Work Order ID 82349

Item ID: D412-664-203

Item Name: Crosstube Aft

DRAWING NO. D412-664-243	TITLE CROSSTUBE ASSEMBLY (412 HI AFT)	REV. E	DART AEROSPACE LTD ENGINEERING ORDER		D.E.O. NO. D412-664-243-E-1	SHEET NO. SHEET 1 OF 2	SCALE NTS
DRAWN	CHECKED	MFG. APPR.	APPROVED	DE APPR.			
DATE 11.03.31	DATE 11/03/31	DATE 11.03.31	DATE 11/03/31	DATE 11-03-31

DRAWING NO. D412-664-243	TITLE CROSSTUBE ASSEMBLY (412 HI AFT)	REV. E	DART AEROSPACE LTD ENGINEERING ORDER	D.E.O. NO. D412-664-243-E-1	SHEET NO. SHEET 2 OF 2	SCALE NTS
DRAWN	CHECKED	MFG. APPR.	APPROVED	DE APPR.		
DATE 11.03.31	DATE 11.03.31	DATE 11.03.31	DATE 11.03.31	DATE 11.03.31

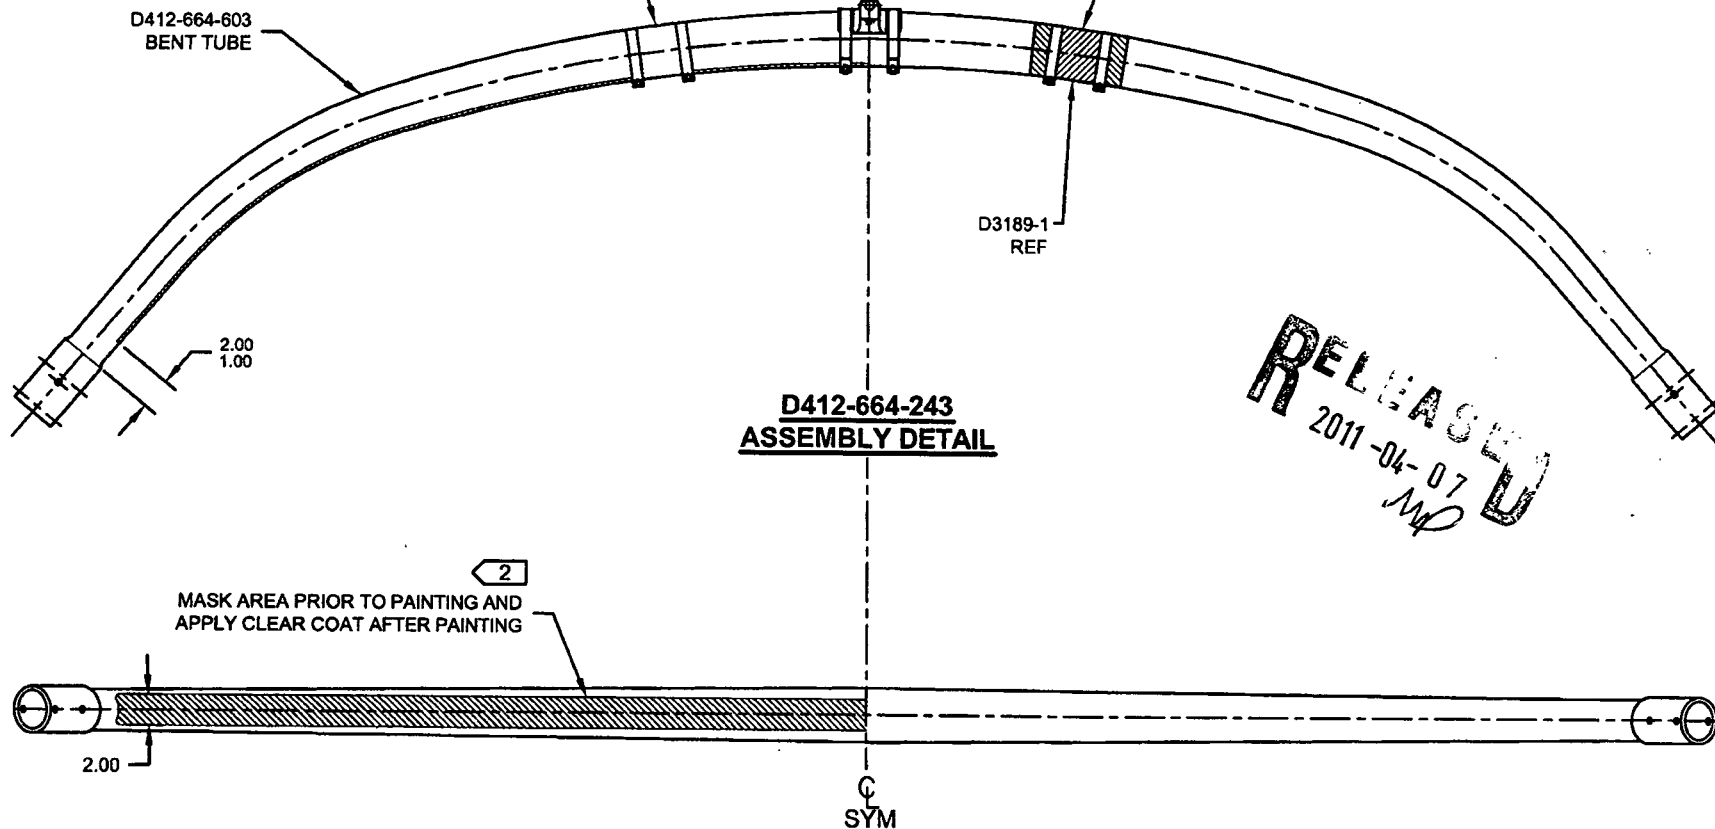
IS:

D3189-1 CHAFING SHIELD (1, INSTALLED OVER PROSEAL 890)
MS21920-28 CLAMP, 2X
2 PL

WAS:

D2856-600-1009 ABRASION STRIP
D3189-1 CHAFING SHIELD (1, INSTALLED OVER ABRASION STRIP)
MS21920-28 CLAMP, 2X
2 PL

CRUSHING OF D91L-664-243

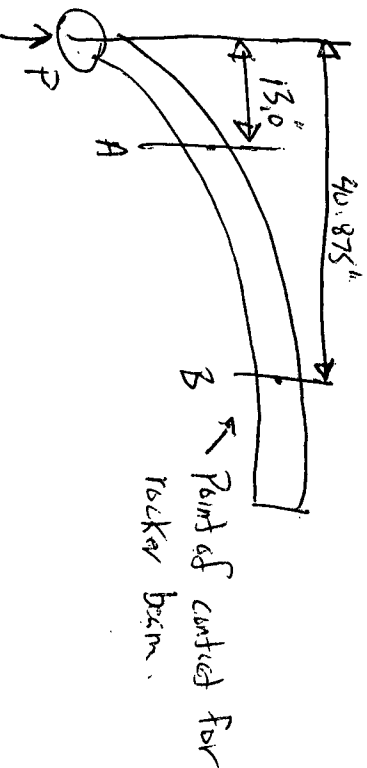
Acceptability of 8% CRUSHING AT END OF BEND

Point A: $\Delta D_1 = 2.961$, $\Delta D_2 = 2.522$ "

CRUSHING = $(2.961 - 2.522) / (2.961 + 2.522) = 8\%$
 $I = 1.676 \text{ in}^4$ (From AutoCAD)

Point B: $\Delta D_1 = 3.357$, $I = 4.613 \text{ in}^4$

A: $F = M_c / I = P \times 13 \times 2.961 / 2 \times 1.676 = 11.484 \cdot P$
 B: $= P \times 40.875 \times 3.357 / 2 \times 4.613 = 14.651 \cdot P$

M.S. = $14.651 / 11.484 - 1 = 0.27$

o. Tube will break at rocker beam contact before area of 8% crushing, 8% crushing in area at end of tube bend is acceptable
